To:	Commercial Real Estate Management, City of Toronto Metro Hall 2nd floor 55 John Street Toronto ON M5V 3C6	Addendum No:	05
		Project No:	21025 211018
Attention:	Bonita Lee	File No:	6-2-1
		Date:	November 28, 2024
		Pages (with cover):	22
Project:	Metro Hall Toronto Early Learning Child Care Centre	Delivery:	Electronic

1.1 Addendum No. 05

TORONTO
Metro Hall Fire Station &
Early Years Child Care Centre
Renovation

NTS	C-A010
-----	--------

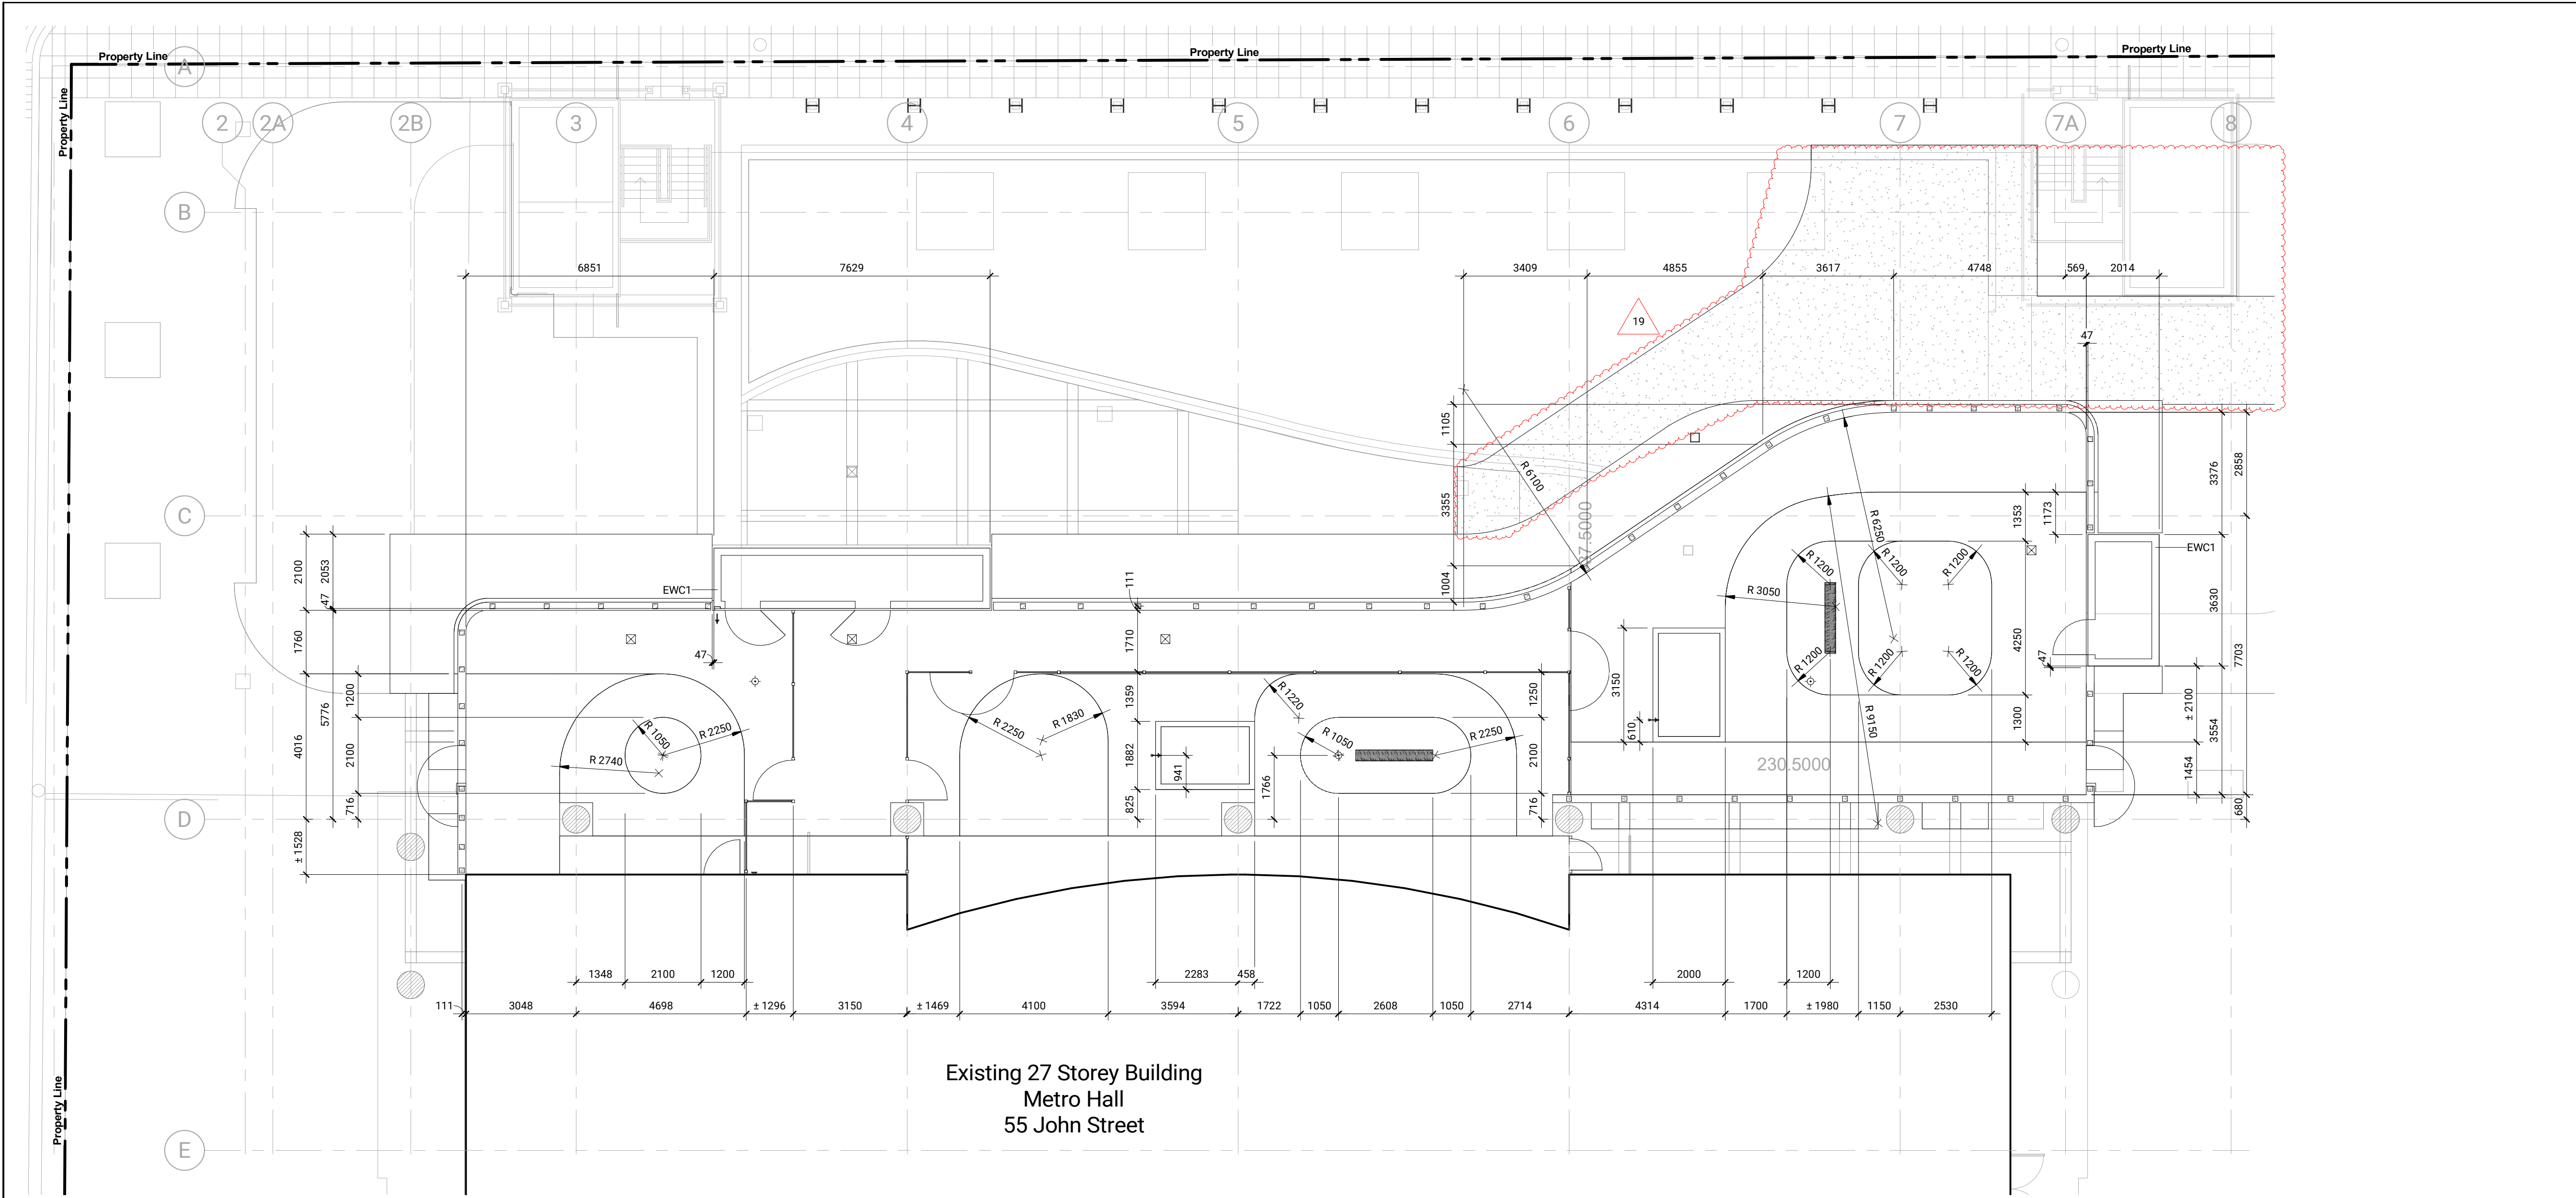
1. 2/C-A010:
 1. Revised drawing to show extent of paving by landscape as indicated.

C-A011

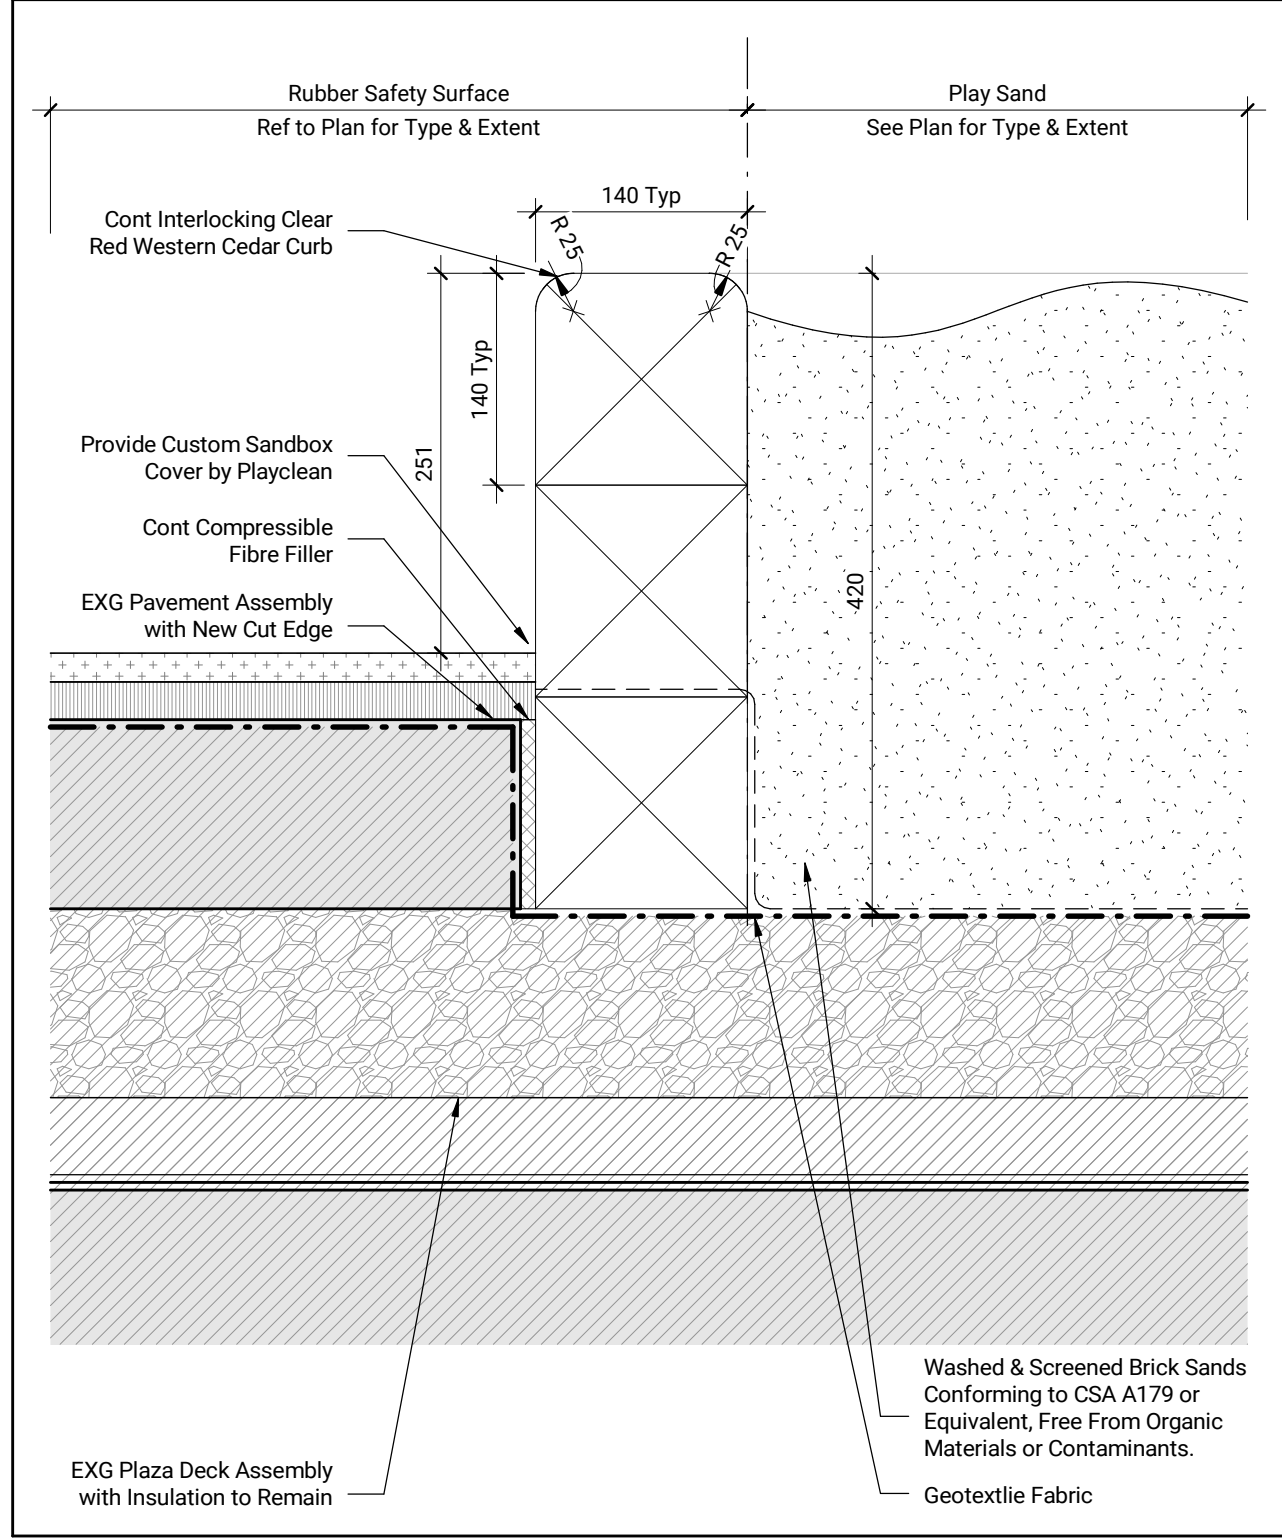
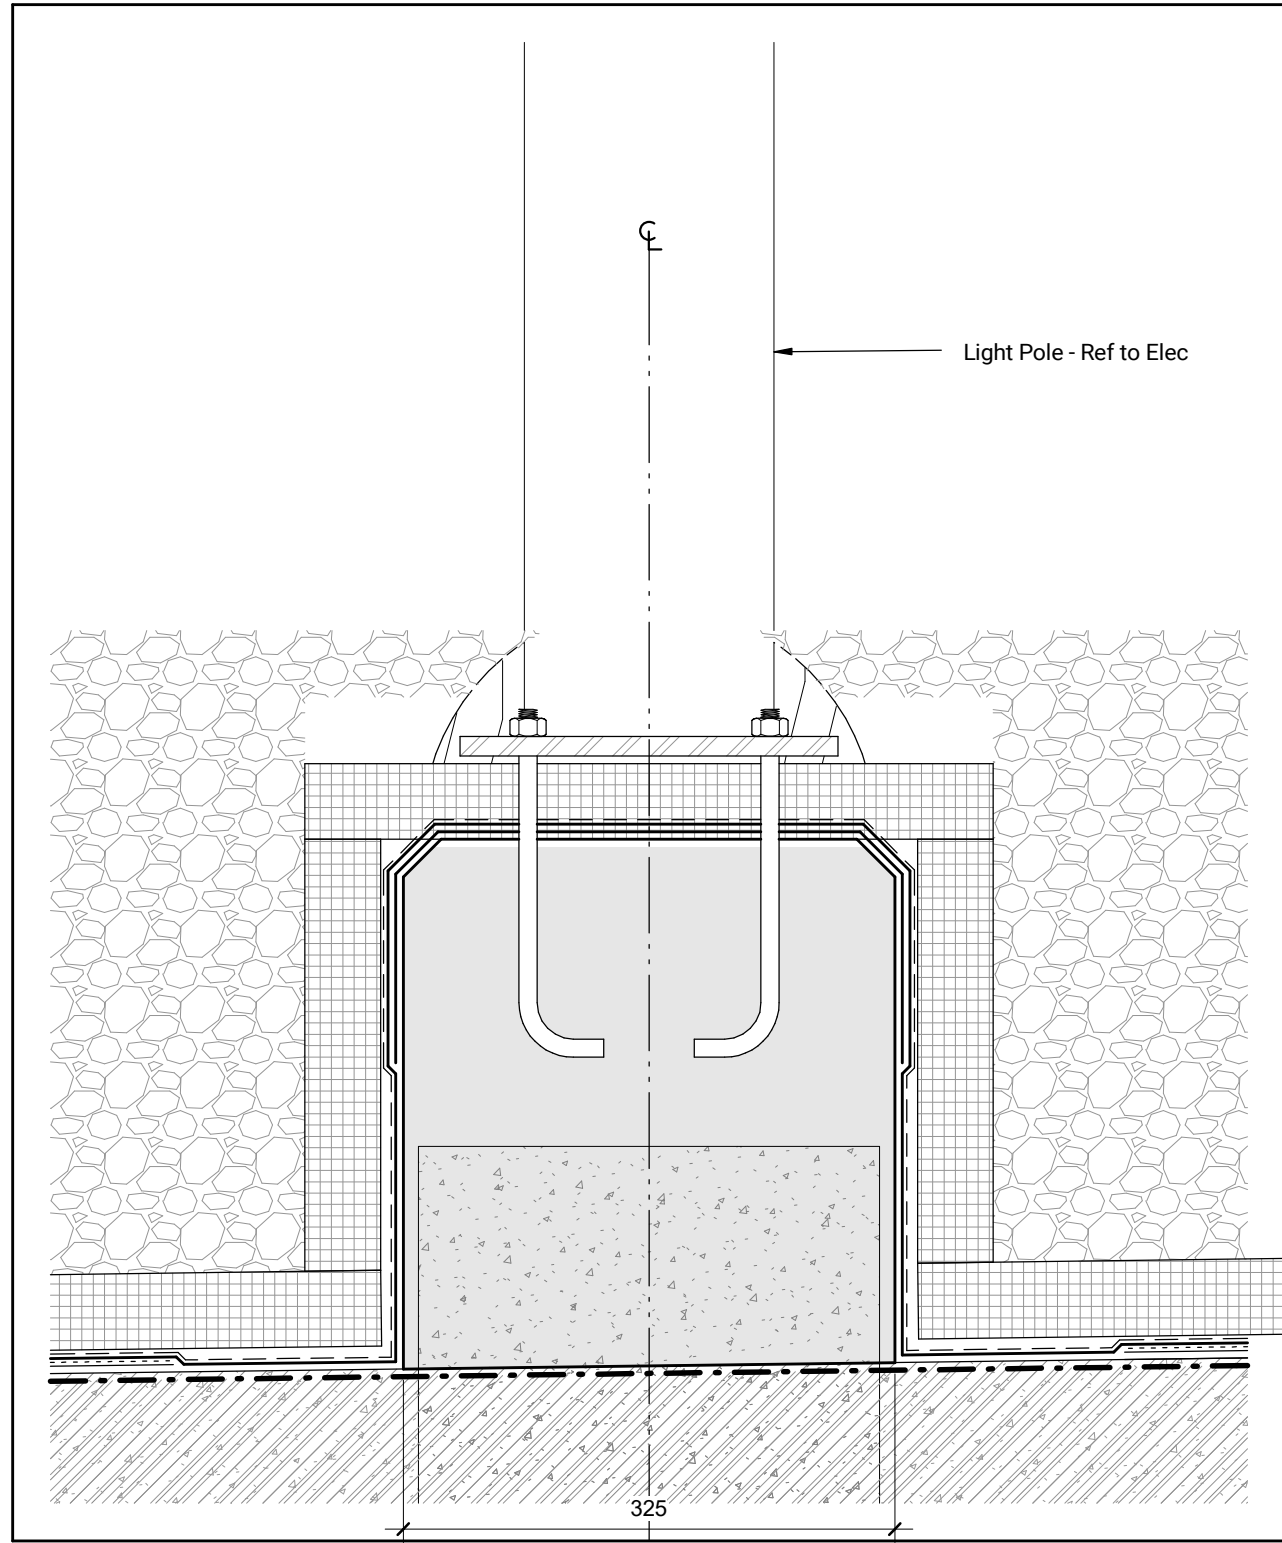
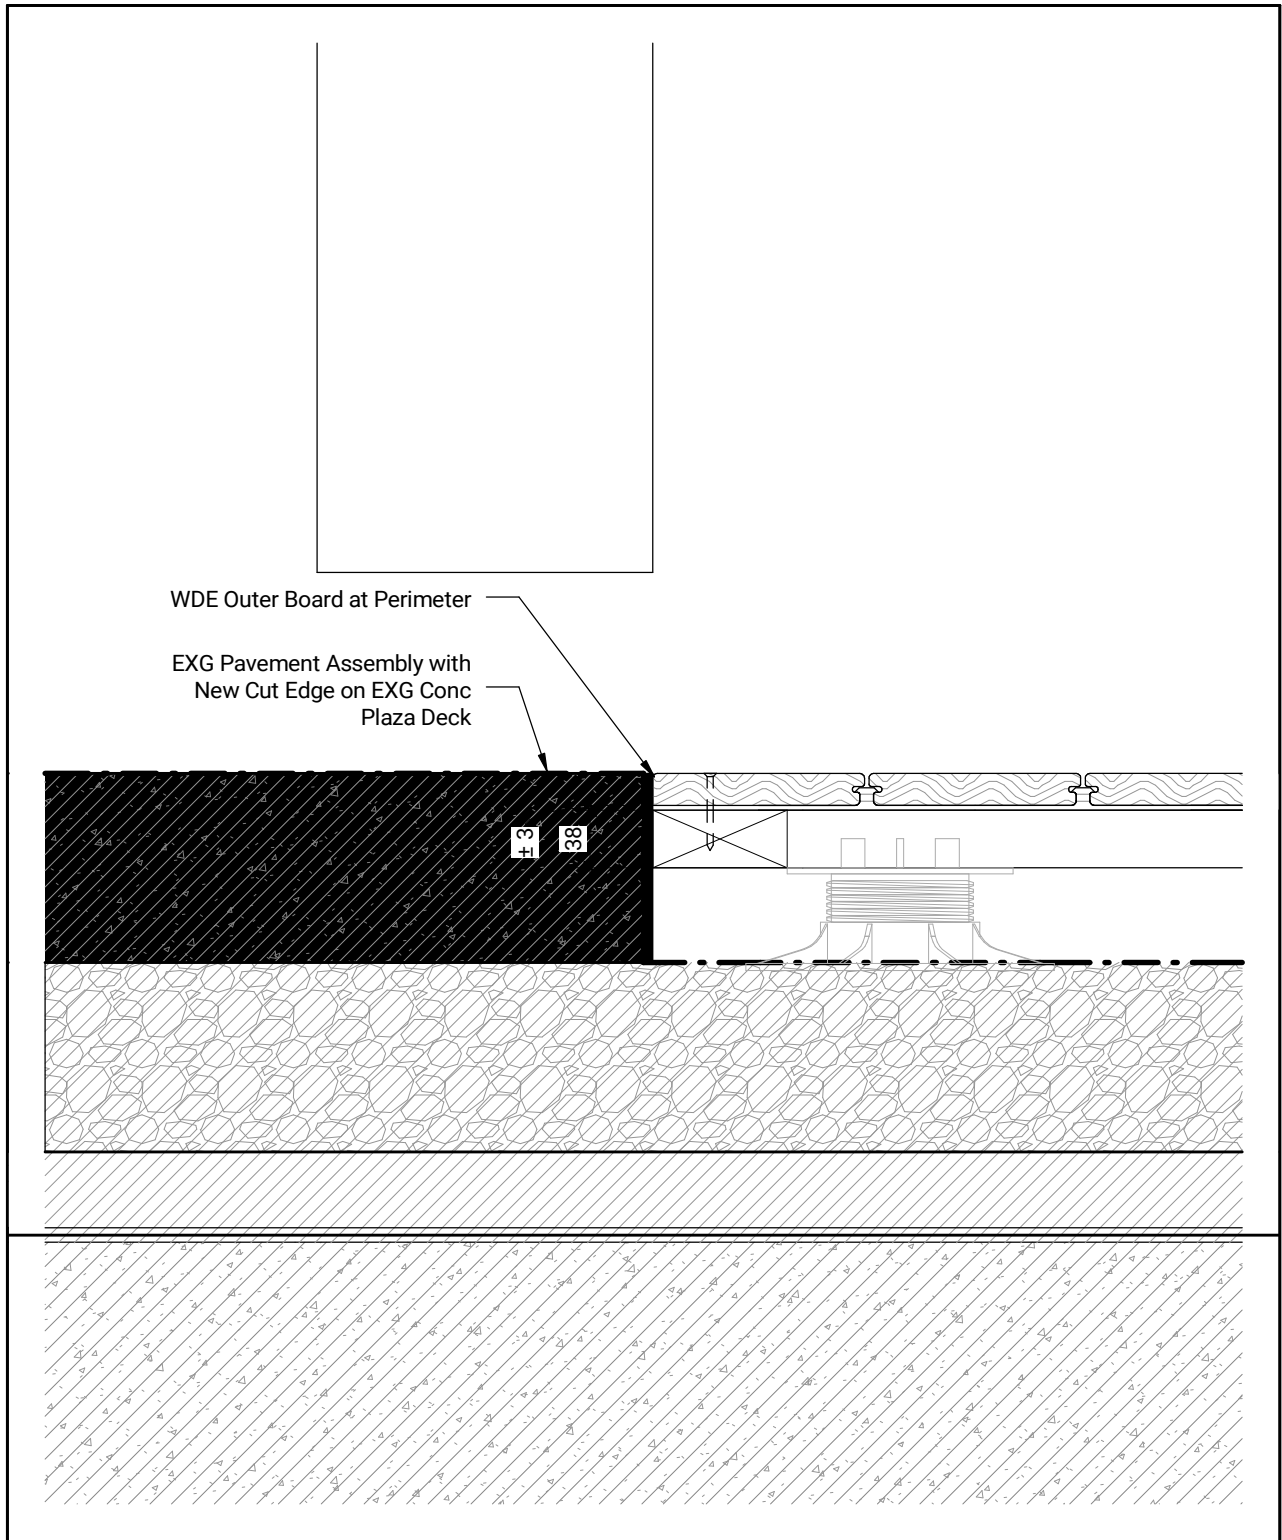
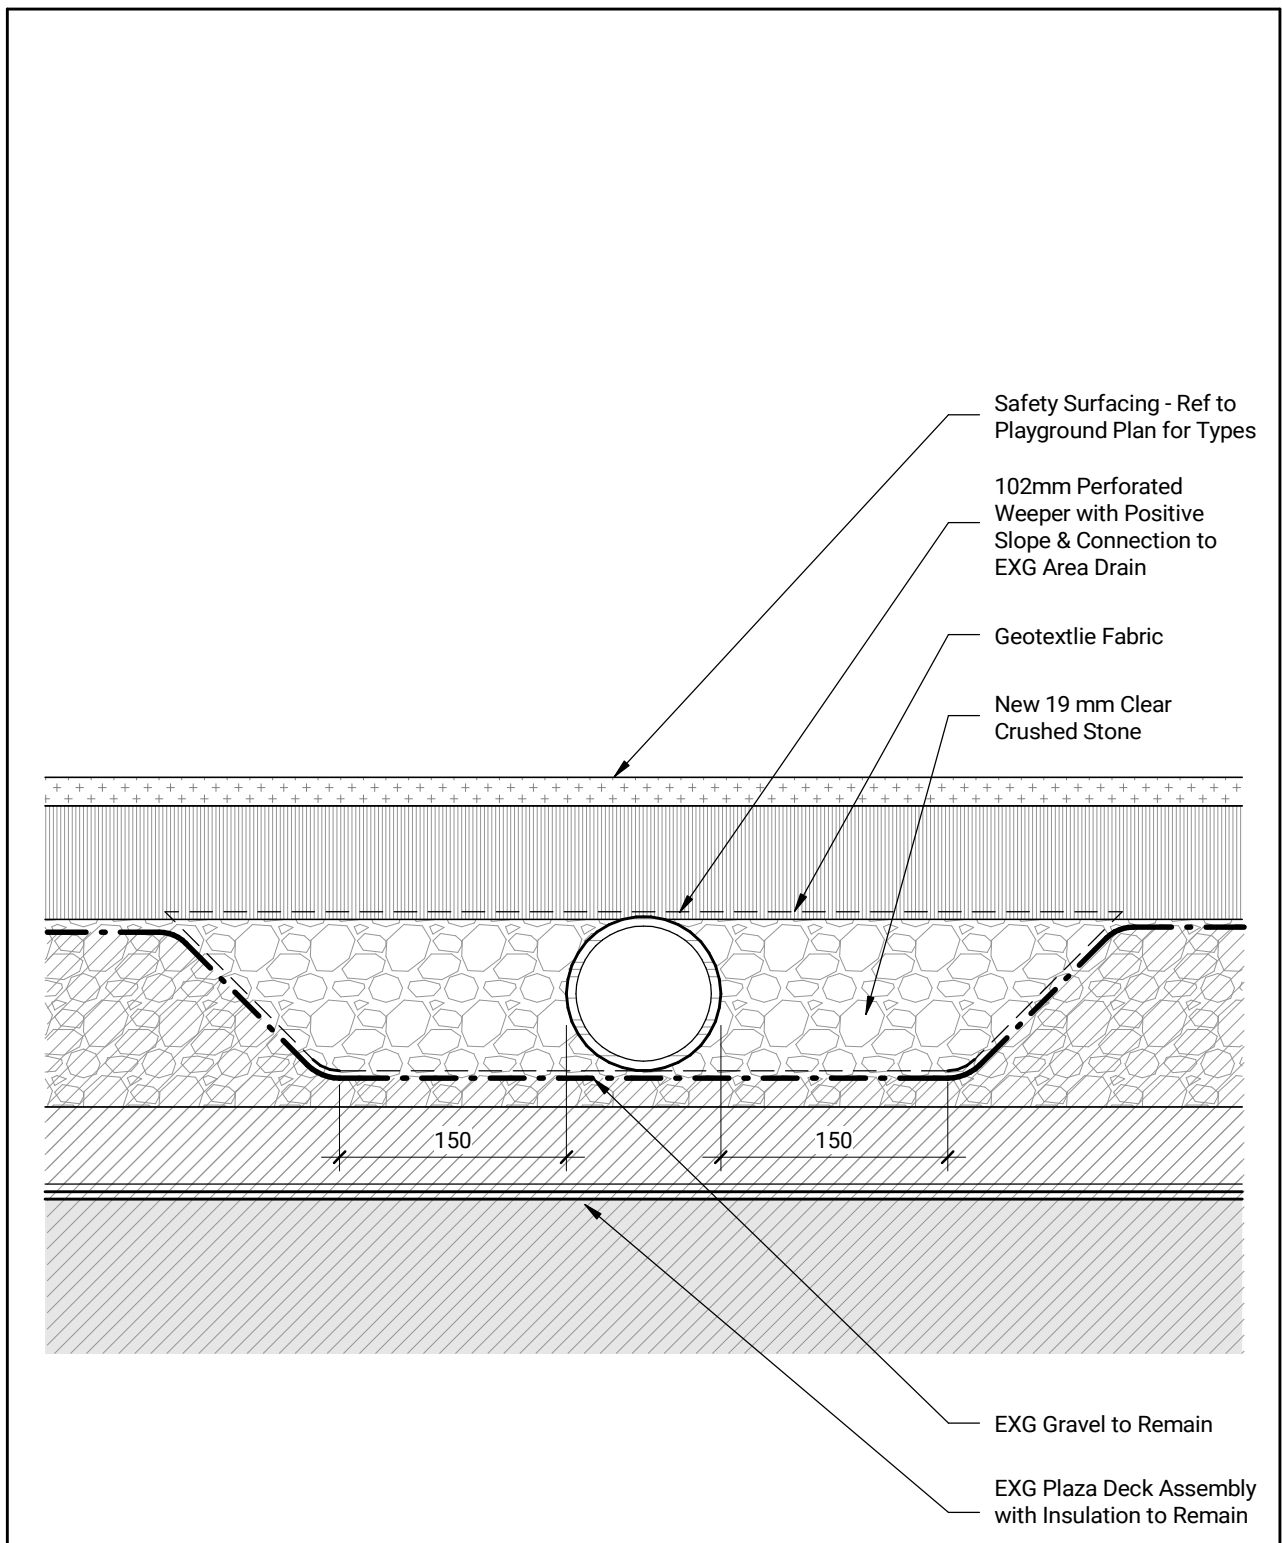
1. 1/C-A011:
 1. Revised drawing to show extent of paving by landscape as indicated.
